**Mount Owen  
Continued Operations Project**  
ENVIRONMENTAL IMPACT STATEMENT

**Response to Submissions**  
REPORT A: NSW Agency and Community Submissions

REPORT A:  
NSW Agency and Community Submissions

Project Director: **Barbara Crossley**  
Project Manager: **David Holmes**  
Report No. **3109/R16/V4**  
Date: **June 2015**

FIGURE 4.6

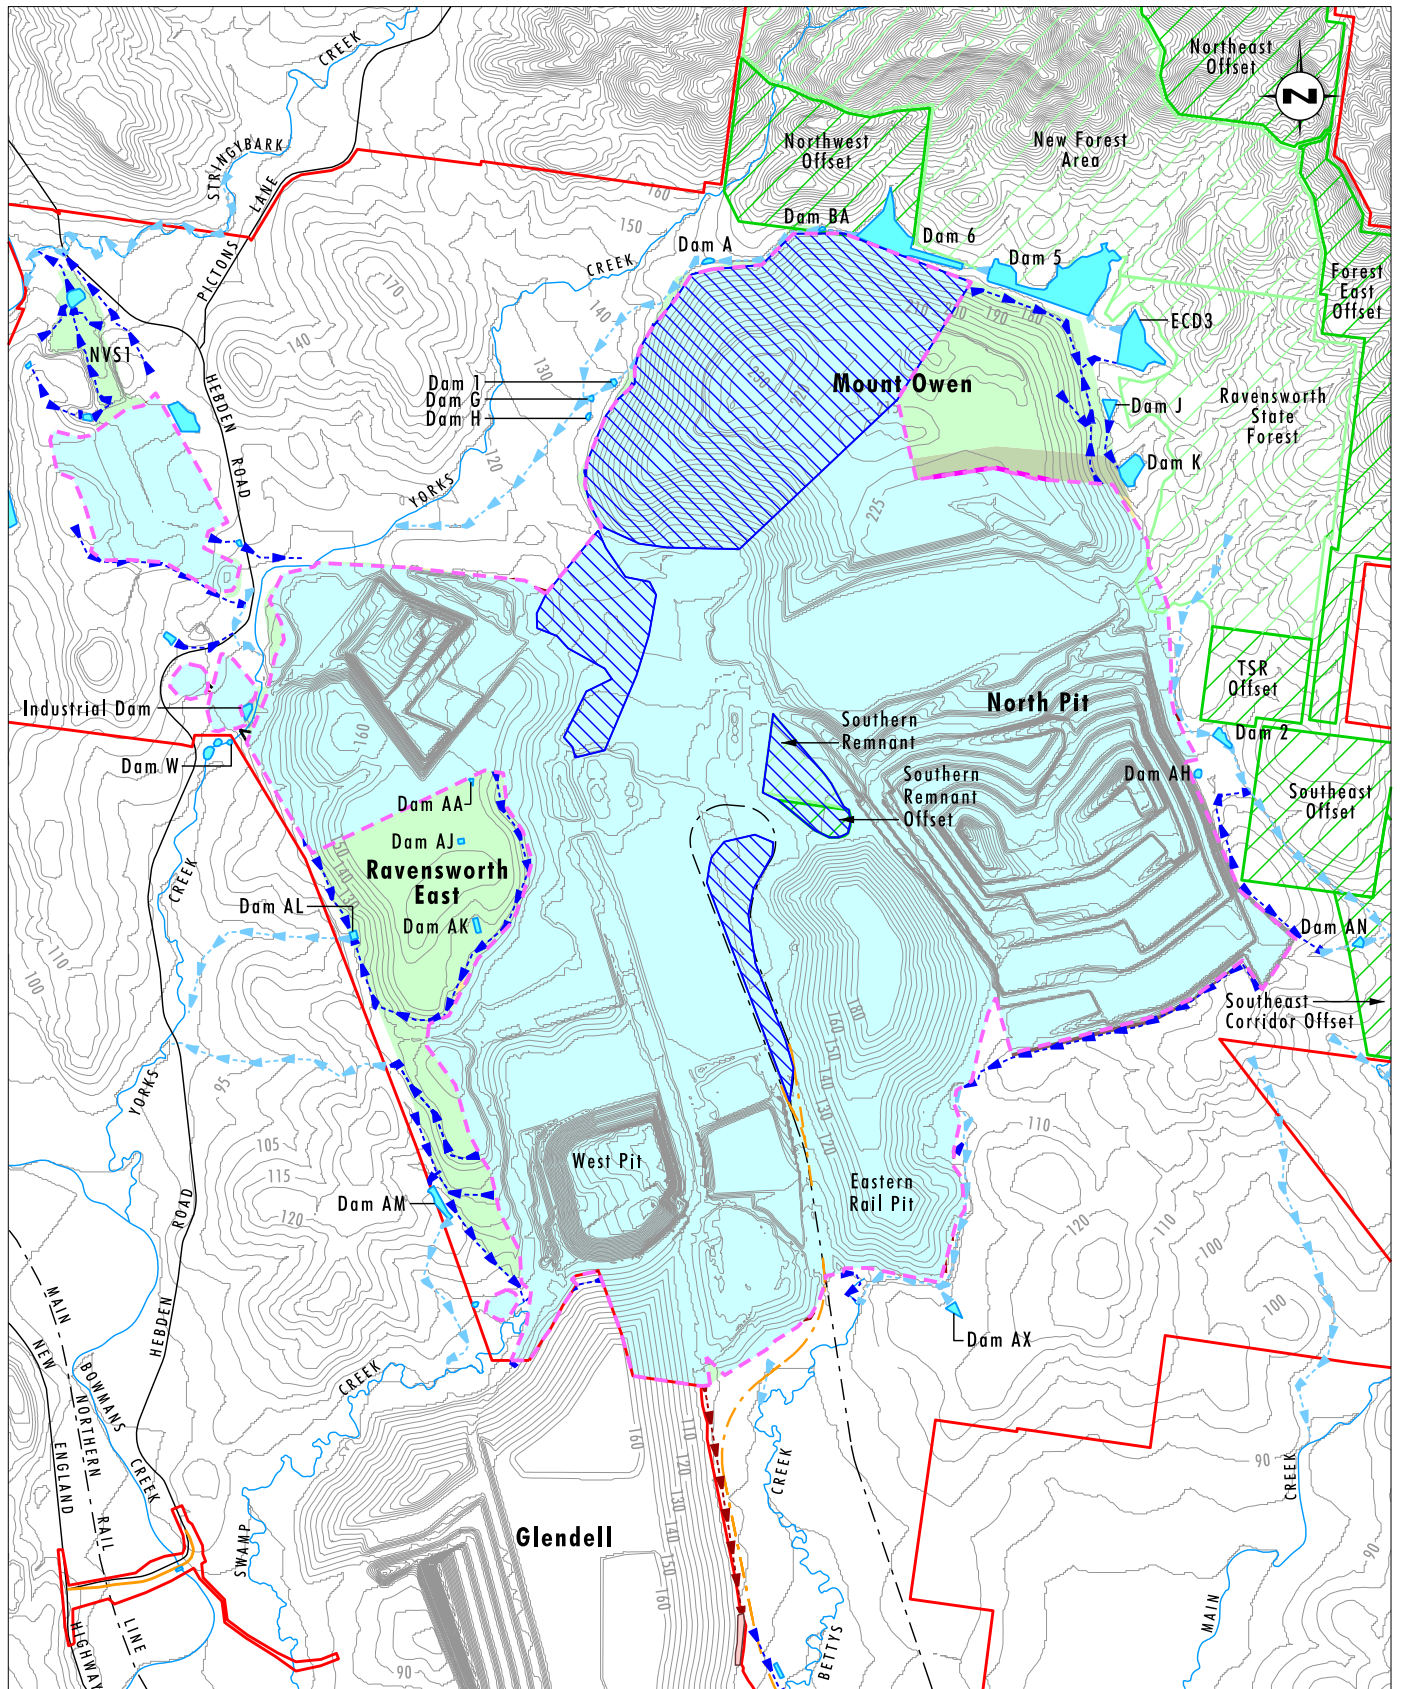
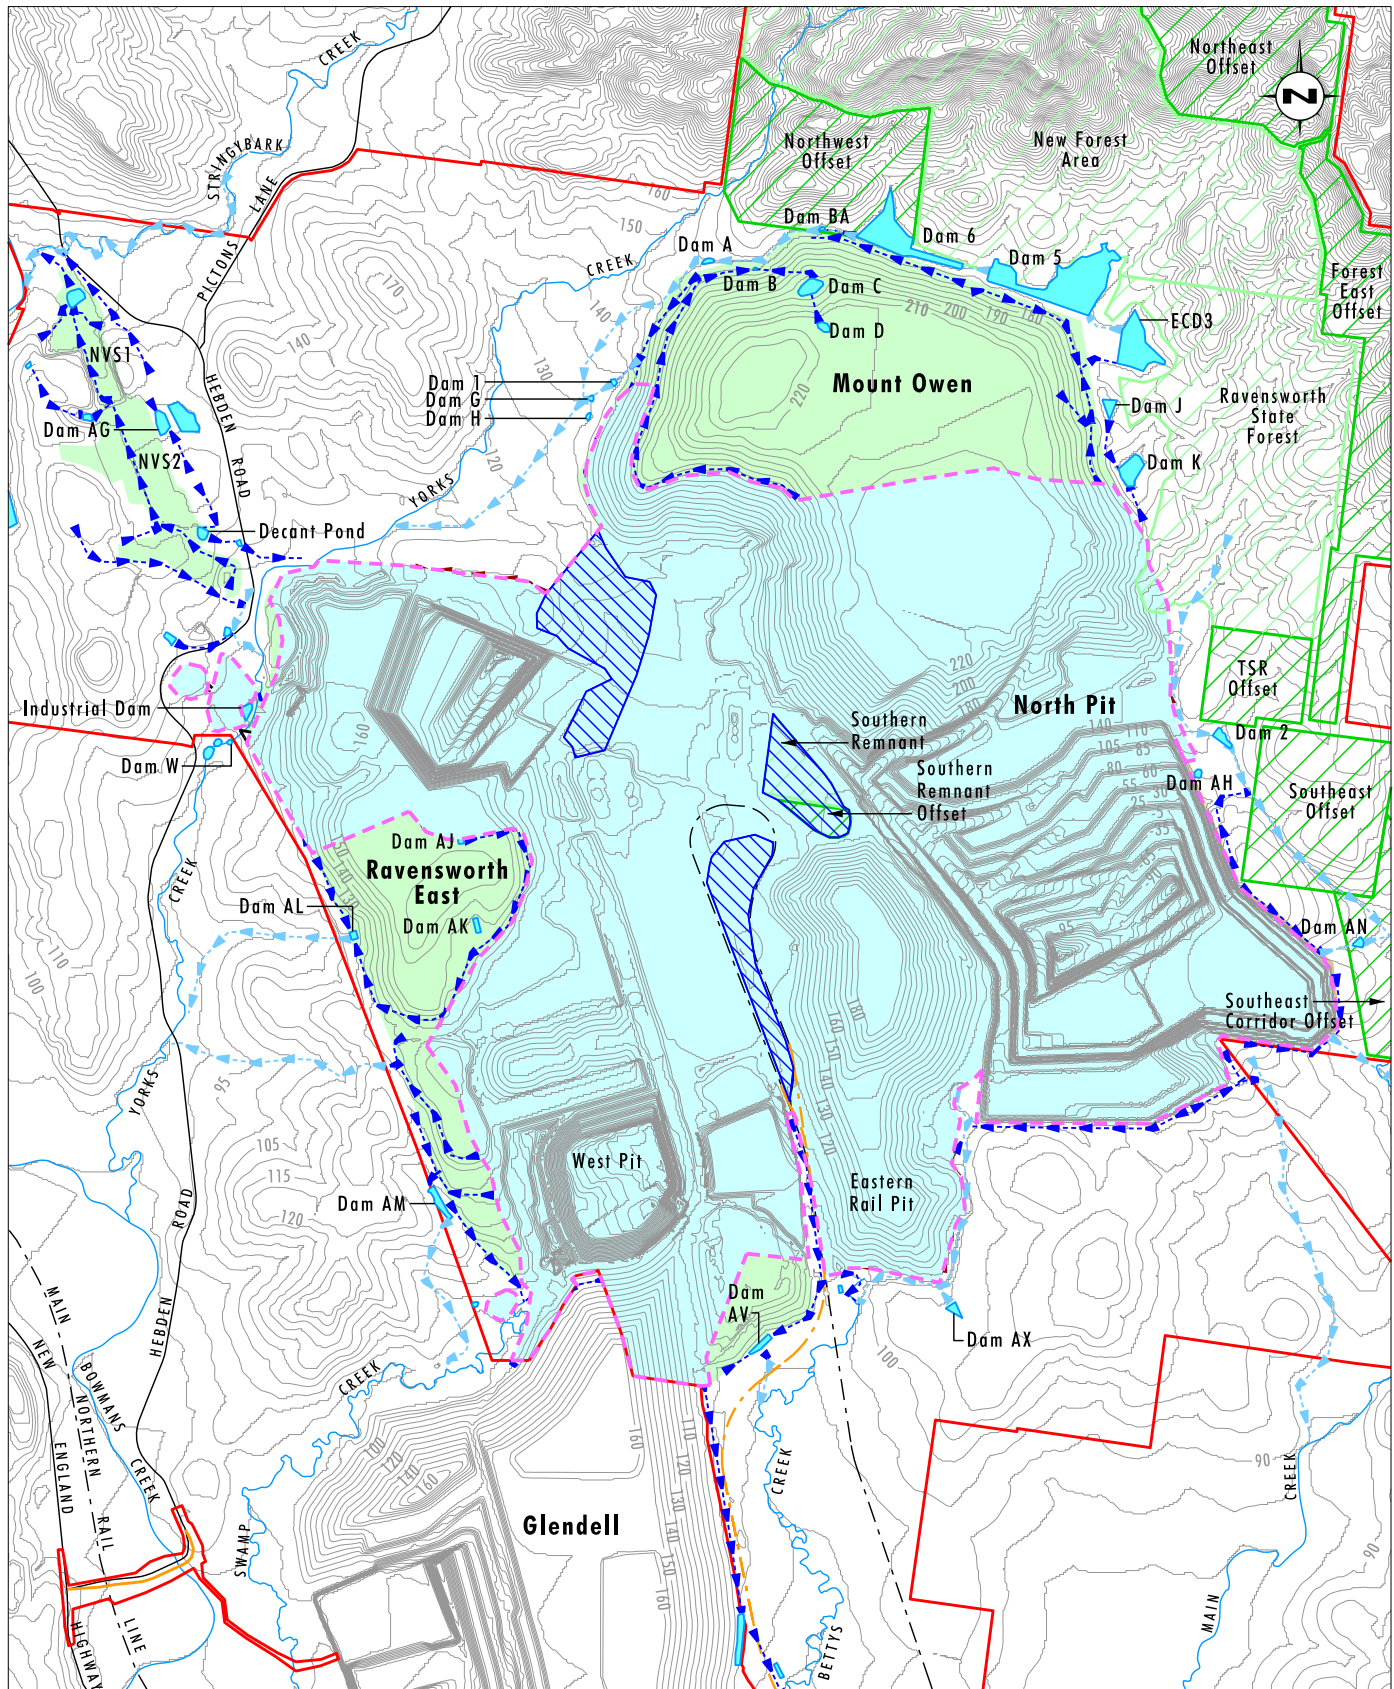
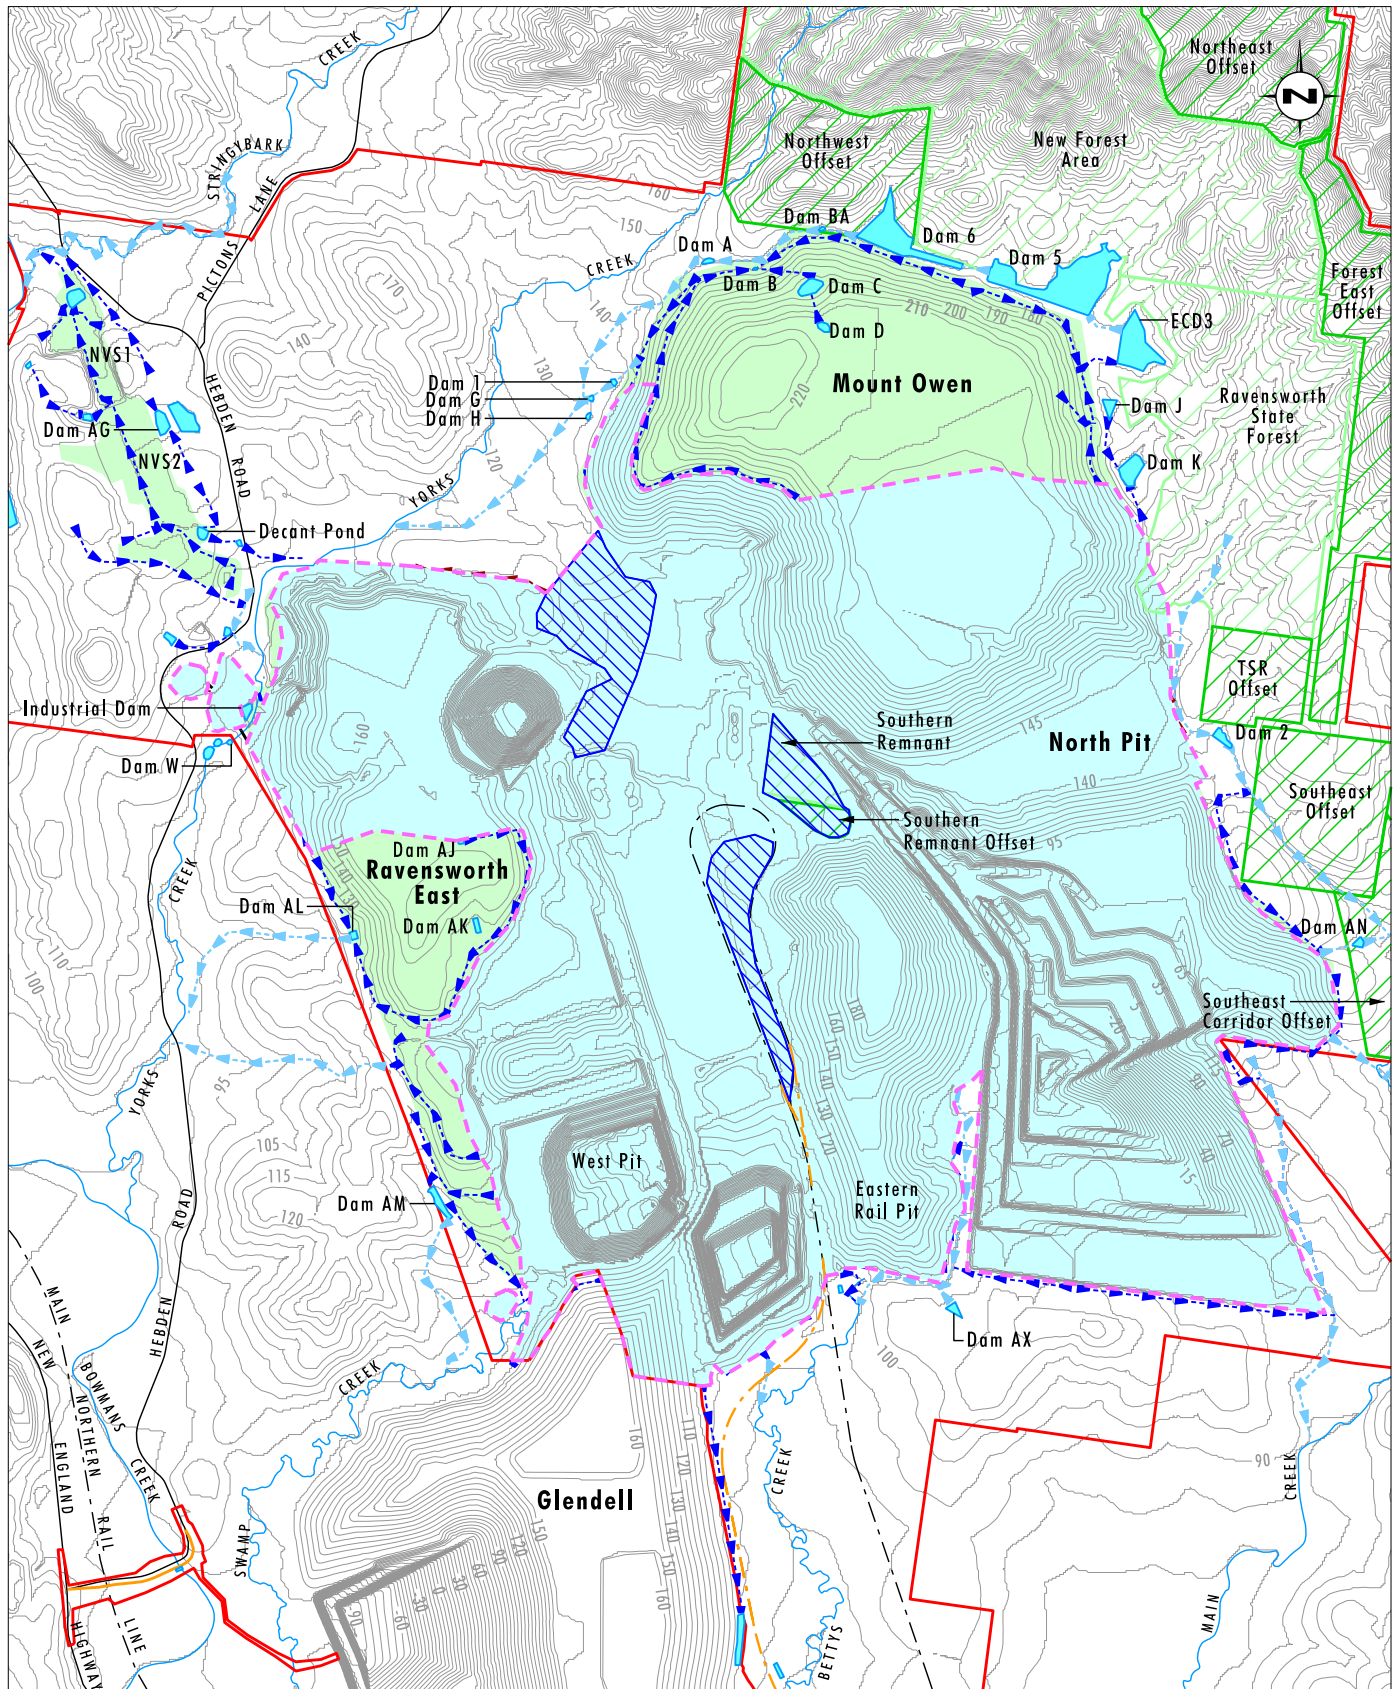
***Figures 4.1-4.5 (from the EIS) show the conceptual surface water management of the site, including clean, dirty and mine water flow paths. Office of Water requires a flow chart or schematic to show more clearly the exact flow paths of water onsite at different stages of the mine's life in order to ensure the clean water diversion system is efficient and all clean water is accounted for or licensed appropriately. For example, it appears from the figures that clean water will be diverted into the "Rail Loop Dam" at years 1, 5 and 10, which appears to be a mine water dam. Further information and a document showing the flow paths more clearly is required to further assess the clean water management system and any associated licensing requirements.***

One of the key objectives of the Mount Owen Water Management System is the diversion of clean water around mining operations to minimise capture of upslope runoff and separate clean water runoff from mining activities.

**Figures 4.6 to 4.8** show the extent of the water management system based on the conceptual mine plans for Years 1, 5 and 10 of the Project. These figures also show the existing and proposed clean water diversions for the Project and identify undisturbed areas where clean water runoff will be captured during each stage. This includes an area during Year 1 of the Project that is rehabilitated clean catchment with clean water runoff that will be captured during Year 1 of the Project. The areas identified as clean water runoff capture are approximately 277.5 hectares in Year 1, reducing to approximately 71.6 hectares in Years 5 and 10. Based on 100 per cent capture of runoff at the regional runoff rates (refer to [www.farmdamscalculator.dnr.nsw.gov.au](http://www.farmdamscalculator.dnr.nsw.gov.au)) of 0.7 ML/hectare/year, this equates to capture of approximately 194 ML during Year 1 and approximately 50 ML during Years 5 and 10. Based on Mount Owen landholdings of approximately 4,913 hectares, Mount Owen has a harvestable rights provision of approximately 344 ML/year (i.e. 4913 ha x 0.7 ML/ha/yr x 10% harvestable rights provision). As such, the capture of clean water runoff (as outlined above and shown on the **Figures 4.6 to 4.8**) is within the harvestable rights provisions of Mount Owen.

FIGURE 4.10

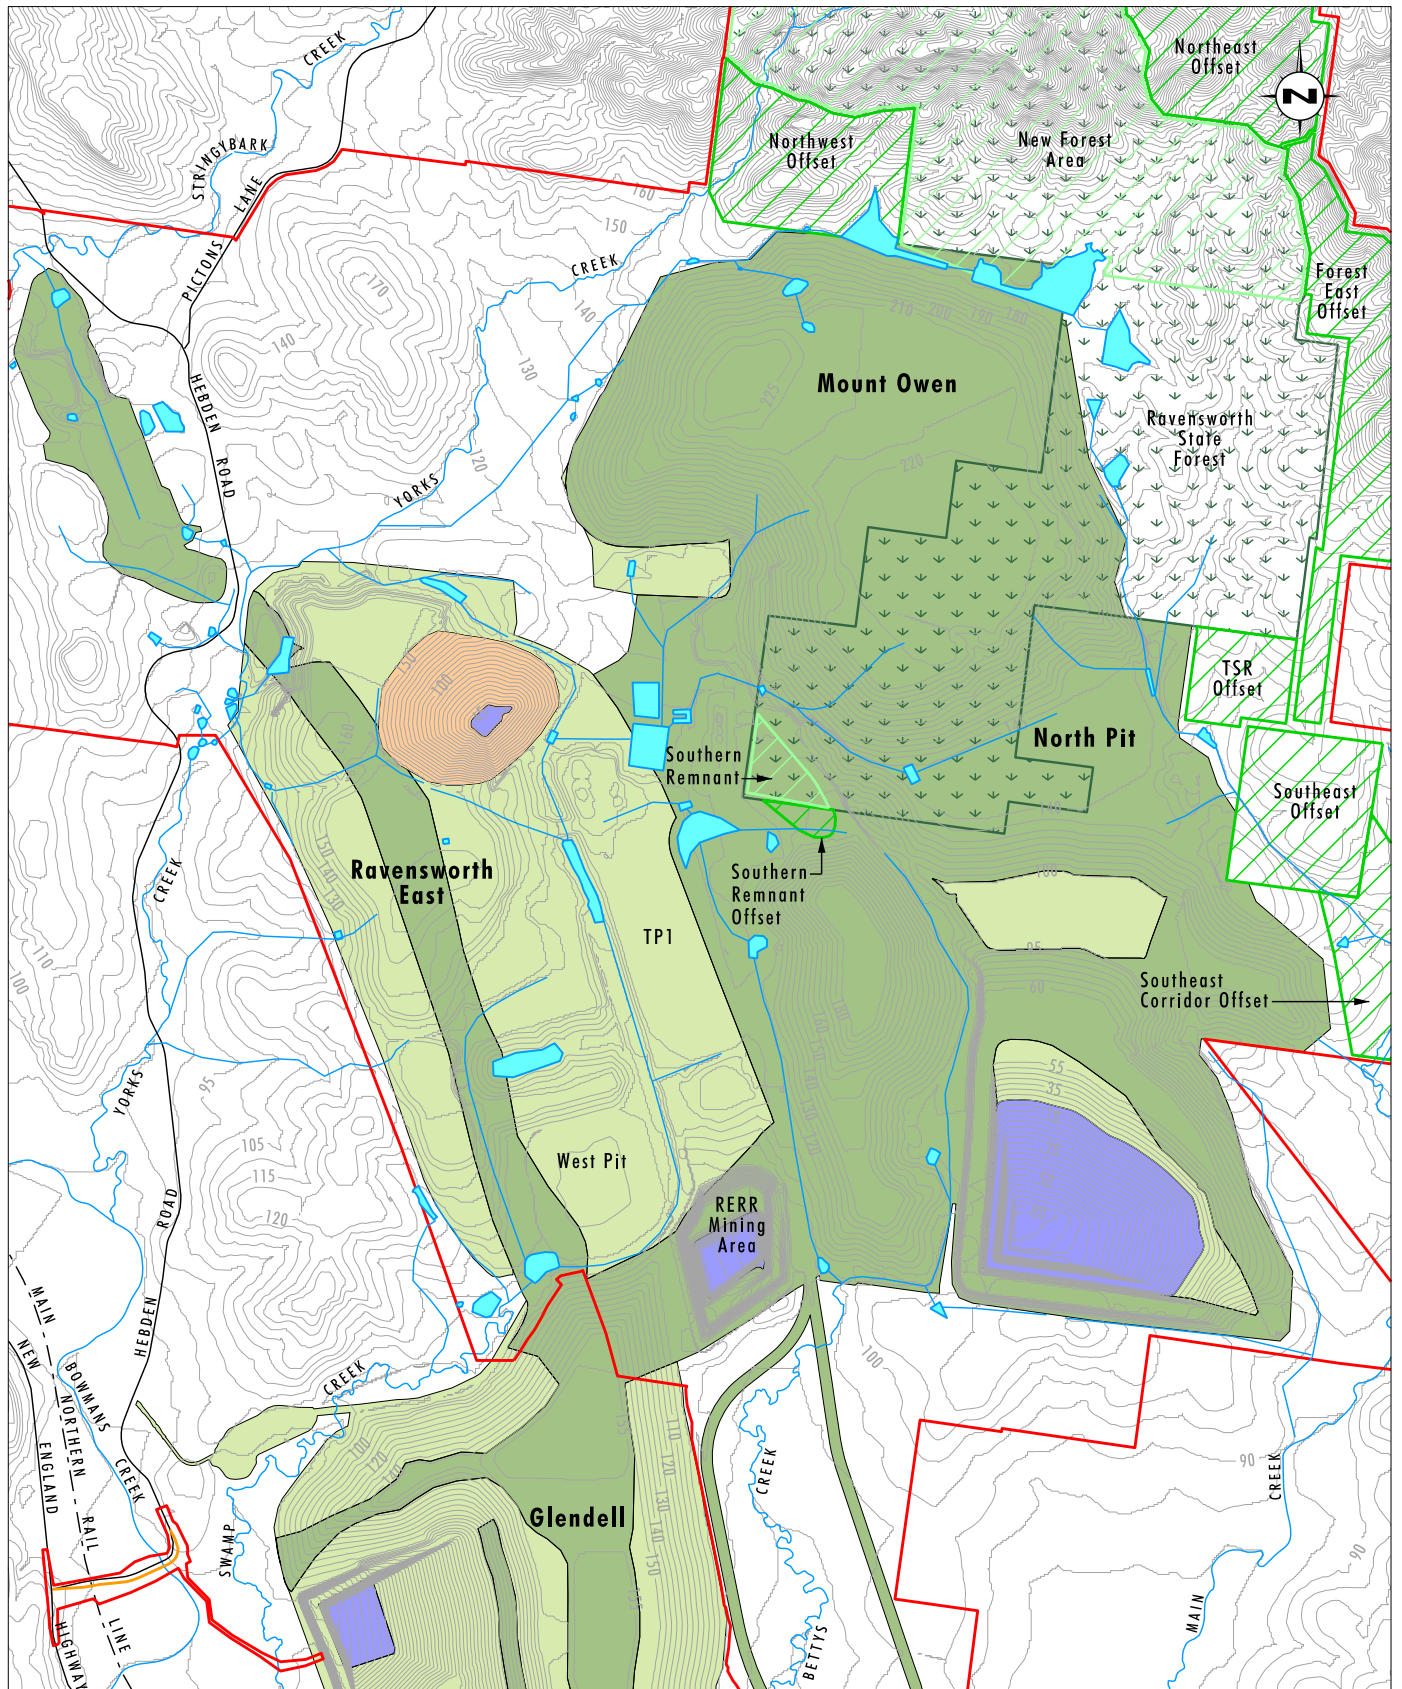
***Office of water requires further information on the design of the final landform, with consideration of the hydrological, geomorphic and ecological function of the landform. The proposed landform and final surface water management system (Figure 4.5, Surface Water Assessment) shows an extensive network of drains that do not replicate natural drainage or geomorphic patterns (for example drains close together running in opposite directions). Comment is sought on how natural hydrological and geomorphic conditions will be considered in the design of the final landform.***

**Figure 4.10** shows the likely drainage lines in the indicative final landform. The Conceptual Closure Plan developed for the Project will include further consideration of natural hydrological and geomorphic conditions in the development of drainage lines. The MOPs developed for the operations will include further detail on the drainage in parts of the rehabilitated landform that will be returned to the surrounding clean catchments. The Detailed Closure Plan for the Project developed within 5 years of proposed closure, will include greater detail on drainage in the final landform. This Plan will be developed having regard to the experience in the management of drainage in the landform of the Mount Owen Operations and natural hydrological and geomorphic conditions.
